TECHNICAL BULLETIN FUJI HEAVY INDUSTRIES LTD.

NO. 200-022

: Installation of Improved Brake Link Rod for Rudder

Pedal Installation

See figure 1.

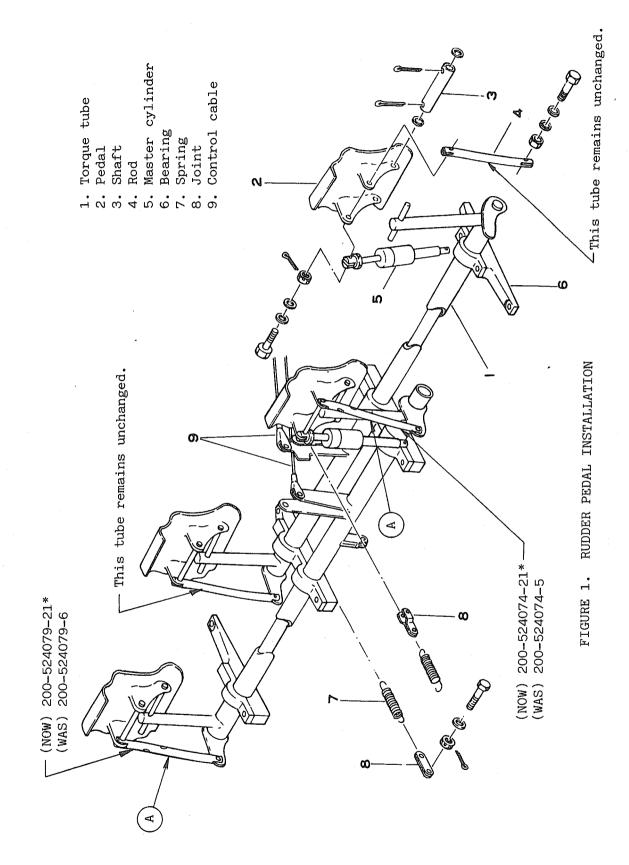
- (1) Remove brake link rods P/N 200-524079-6 and 200-524075-5 (item A, figure 1) from each right pedal of left and right seats.
- (2) Install new rods P/N 200-524079-21 (for right seat) and 200-524074-21 (for left seat).

New rods must be installed as a matched set. Installation of either rod only is not permissible. New rod must be installed with "deeper slot in lower fork end" aft. This ensures adequate clearance between slotted rod end and mating part.

*New tube is 5 mm longer than the existing tube.
